## Korenix JetNet Industrial Managed Switch JetNet 5008G-P SOFTWARE RELEASE Notes

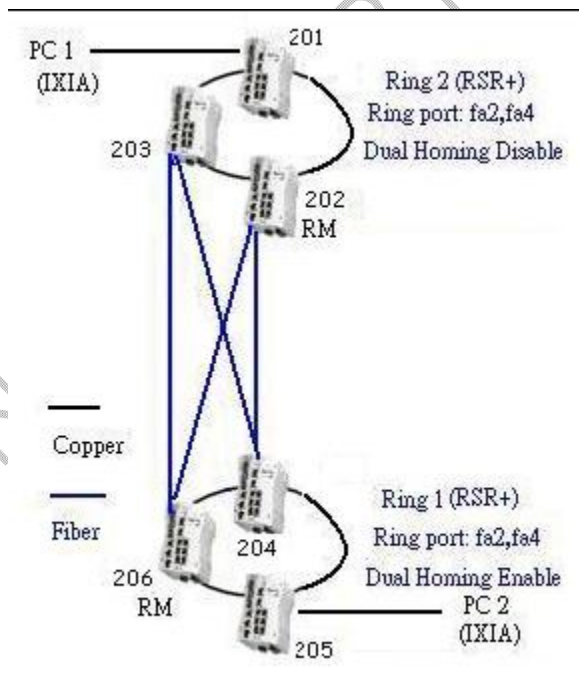
- Rename Super Ring plus (Rapid Super Ring) to Multiple Super Ring with various features as following diagram.
